Sheet: /		File: segment_board.sch	
<b>Title:</b>			
Size: A4	Date:	Rev:	
KiCad E.D.A. kicad (5.1.9-0-10_14)		Id: 1/15

Sheet: /Battery Power Managment/ File: battery_power_manager.sch	
<b>Title:</b>	
Size: A4	Date:
KiCad E.D.A. kicad (5.1.9-0-10_14)	Rev:
	Id: 15/15

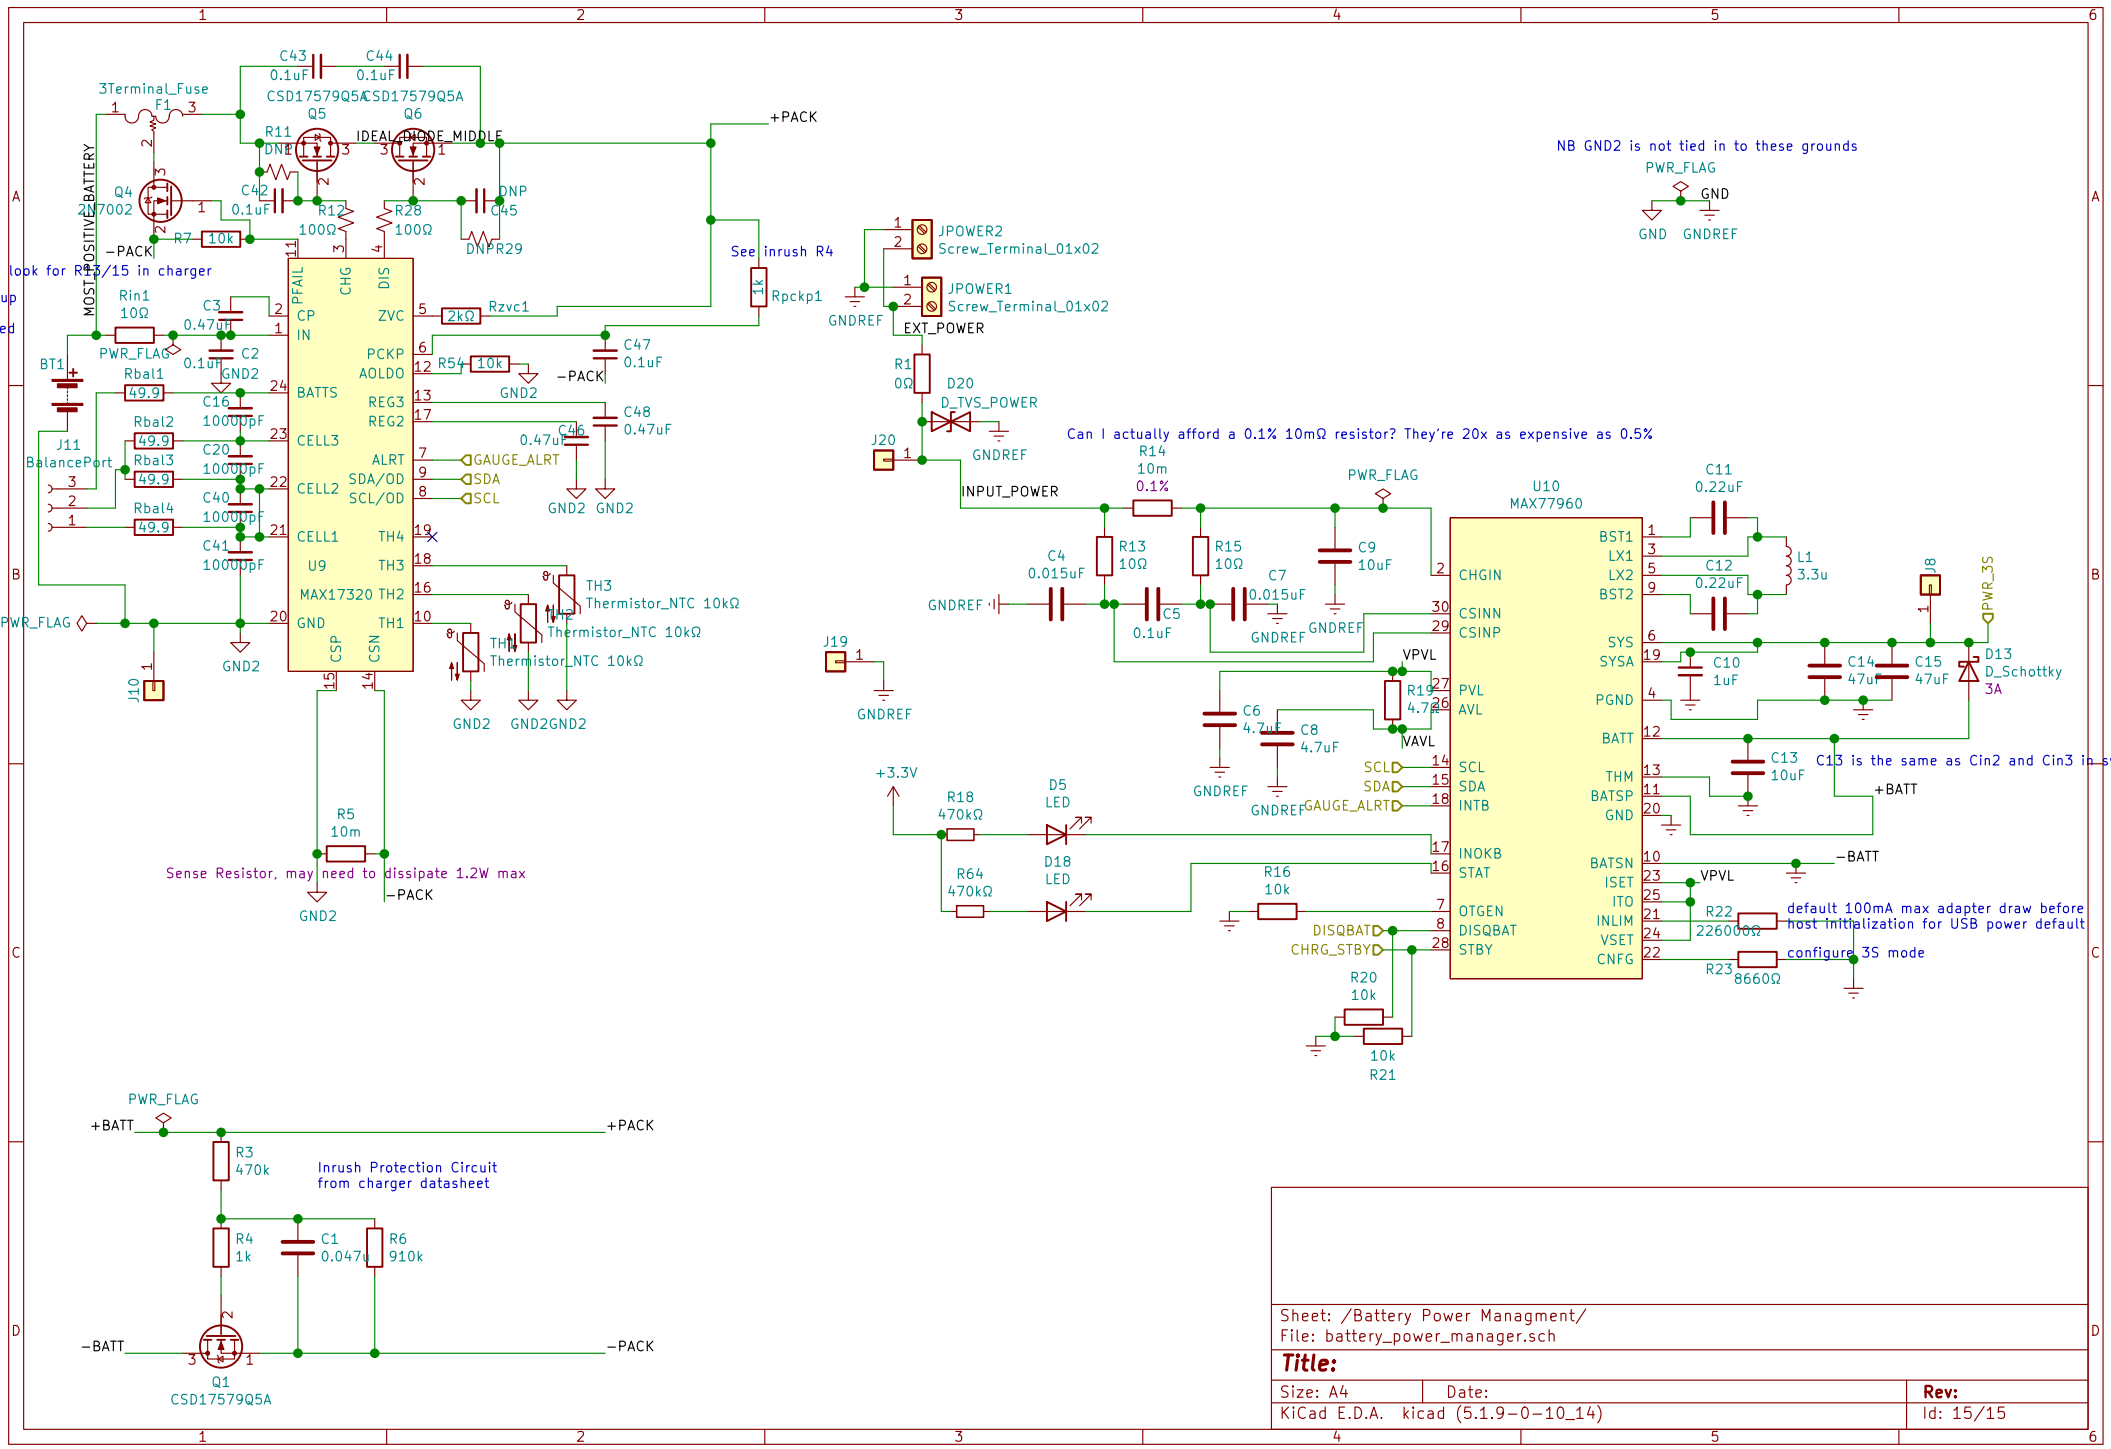
1 should look for R13/15 in charger  
 action setup  
 bal3 bc shorted

NB GND2 is not tied in to these grounds

Can I actually afford a 0.1% 10mΩ resistor? They're 20x as expensive as 0.5%

C13 is the same as Cin2 and Cin3 in switcheer s

default 100mA max adapter draw before host initialization for USB power default  
 configure 3S mode
